ROBERT BERNSTEIN, P.E.
Consulting Transportation Engineer/Planner

SUBJECT: Analysis and Evaluation of Traffic Impacts of Proposed Spokane South Little League Playing Fields in Spokane County, WA

SUBJECT: Review of Traffic Issues Associated with Proposed Spokane South Little League Playing Fields in Spokane County, WA

Figure 1: April 2009 Traffic Volumes

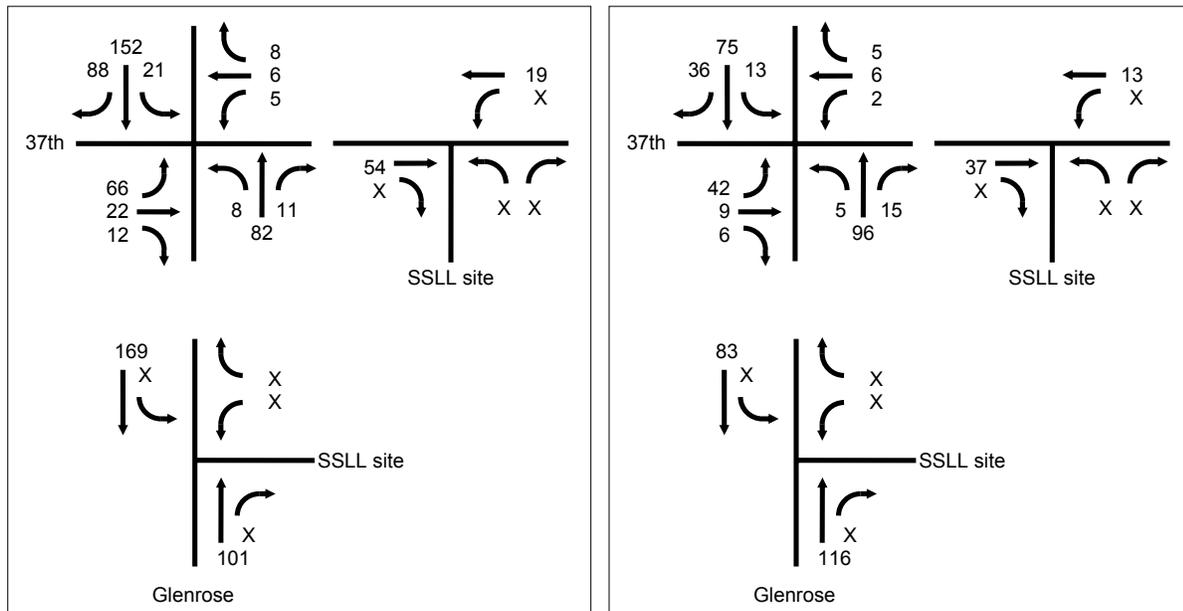
The background traffic volumes used in this analysis (i.e., the traffic not traveling to or from the site) are compiled in **Figure 1** (the background volumes are the April, 2009, intersection counts collected and reported by the Applicant). Site traffic distribution is compiled in the form of intersection volumes in **Figure 2**; trip distributions were compiled for five scenarios:

The peak 15-minute volumes used to do the LOS/delay calculations for this report were determined by adding – for each traffic movement at the intersection – the peak 15-minute volume found in the April, 2009, counts reported by the Applicant and one-half of the estimated 30-minute peak volume for the various episodic peak scenarios (see **Figures 1 and 2**).

Figure 2a: Site-Generated 30-min Peak* Traffic Volumes

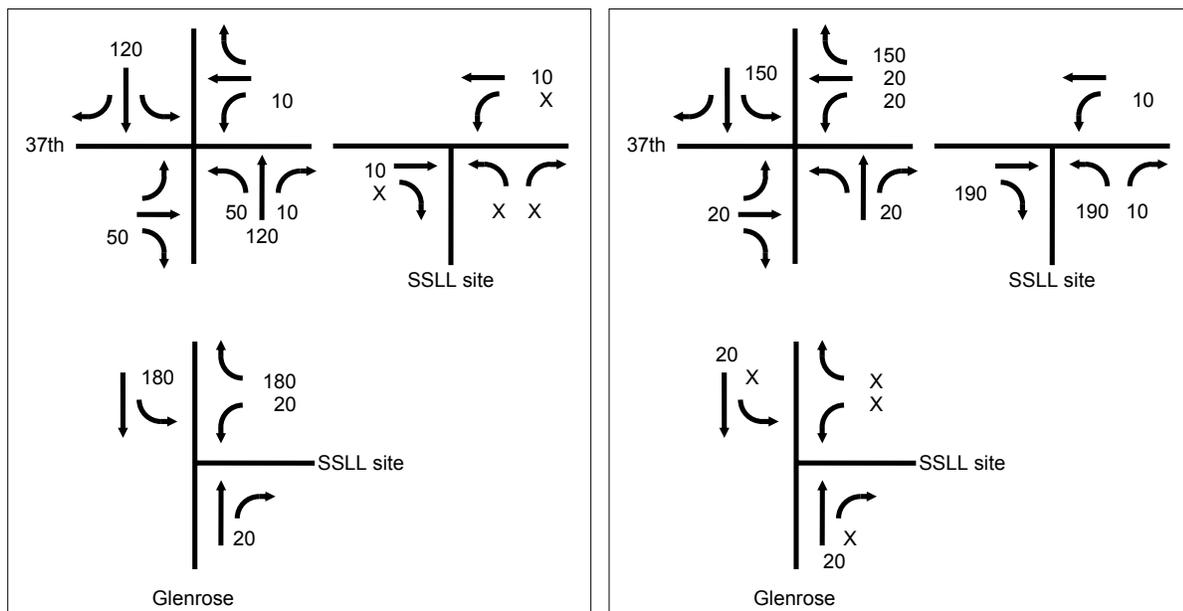
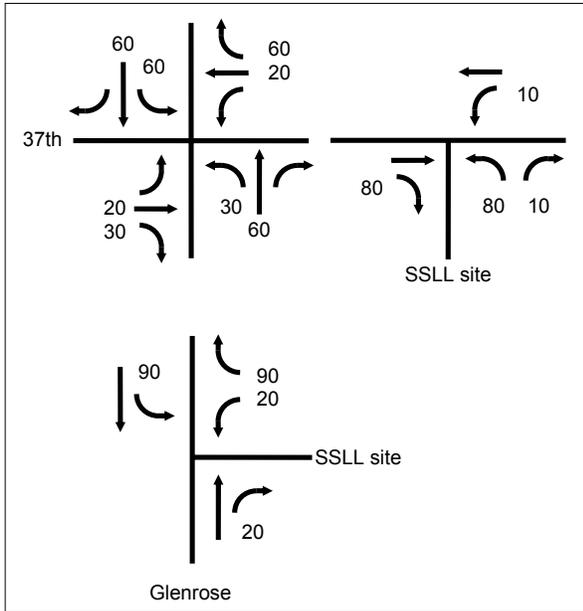
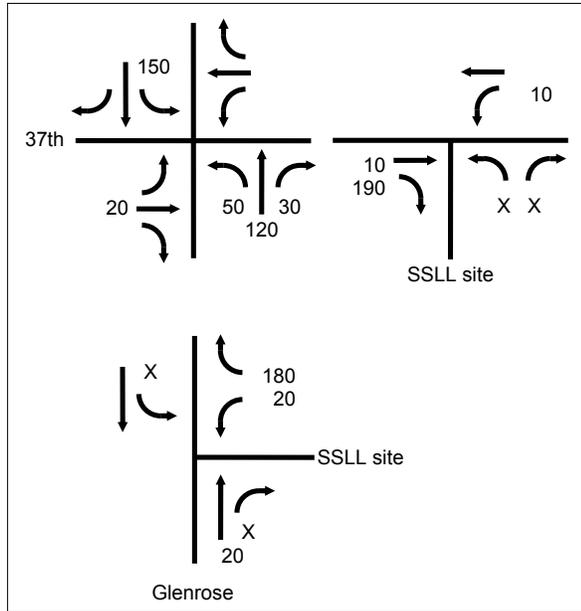
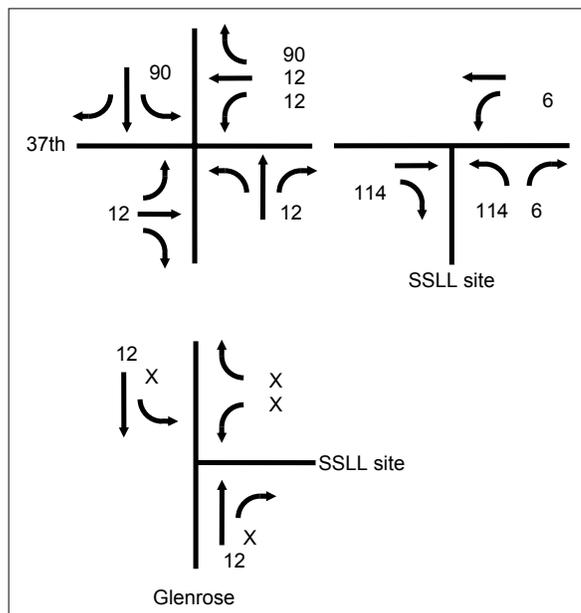
1. Full development (5 ballfields), with one site access on Glenrose
2. Full development (5 ballfields), with one site access on 37th
3. Full development (5 ballfields), with site accesses on Glenrose and on 37th
4. Full development (5 ballfields), with site entrance on 37th and exit on Glenrose
5. Initial development (3 ballfields), with one site access on 37th

As shown in the Table, LOS is good and delays are minimal for existing 2009 conditions at Glenrose/37th. However, the addition of site traffic degrades traffic operations to LOS E-F and increases delays dramatically. The scenarios that generate the greatest volume on the westbound

37th intersection approach and the largest numbers of eastbound through movements across Glenrose degrade LOS and increase delays the most.

Figure 3: Glenrose Road Speed Count Locations

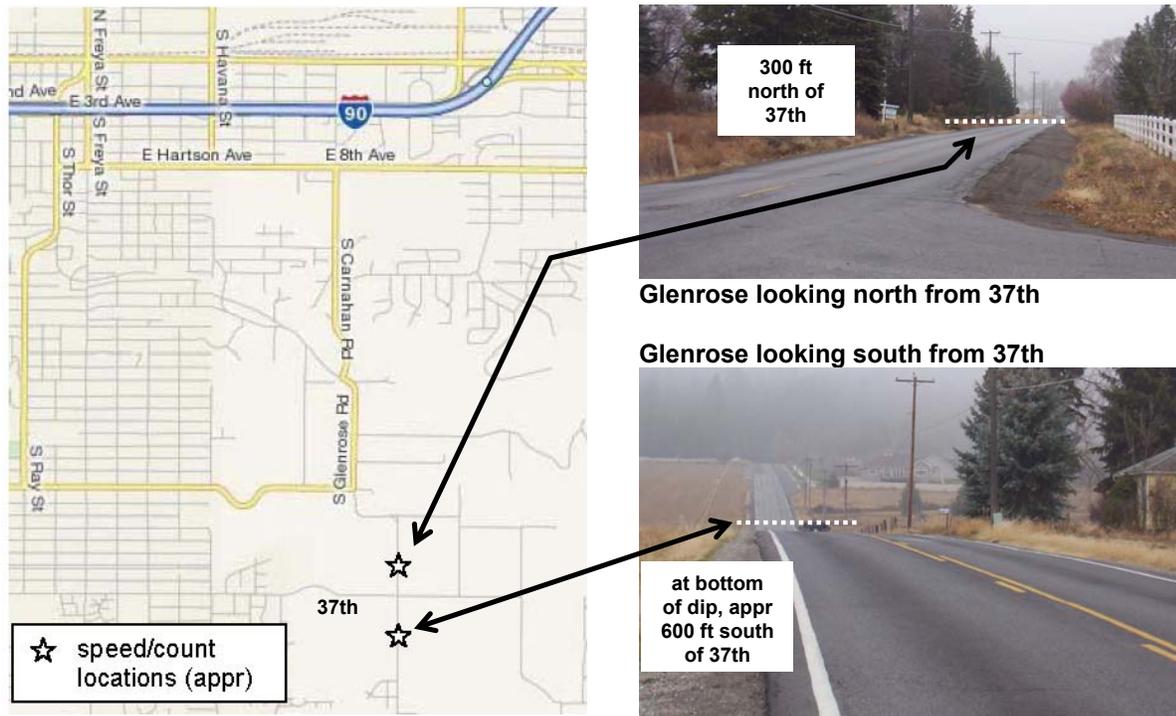
Traffic speed data were collected on Glenrose Road at two key locations, one north of 37th Avenue and one near the location of the proposed site access south of 37th (see **Figure 3**). The speed data were used to determine sight distance requirements.

The speed data are compiled in **Table 1**, and speed limit compliance results at the two count locations are compiled in **Table 2**. As shown in the Tables, speeds on Glenrose Road are excessive (as reported anecdotally by area residents), and compliance with the 35-mph speed limit is minimal.

As shown in the Table, stopping sight distance on southbound Glenrose is 357 feet. This is the minimum distance necessary to maintain safe traffic operations between the roadway crest south of 37th and the back of any queue waiting to turn left into the site access. The Table also shows that entering sight distance to the north for the site access on Glenrose is nearly 500 feet. Since the roadway crest south of 37th limits entering sight distance, the site access must be located at least 500 ft south of it.

- 3.1. Construct a left turn lane in Glenrose Road for southbound site access traffic.
 - 3.2. In order to ensure that site entry queues never form in the southbound Glenrose travel lane, and to provide adequate sight distance for southbound Glenrose traffic approaching the site access and any queues formed there, the site access left turn lane and/or a center median should extend back at least to the roadway crest on Glenrose south of 37th, and preferably all the way to 37th.

4. Because entering sight distance for left-turning traffic exiting the site onto southbound Glenrose is inadequate (due to high speed of Glenrose traffic and the proximity of the hillcrest on Glenrose south of 37th), a left turn acceleration lane is needed south of the site access opposite the needed left turn lane for entering traffic..
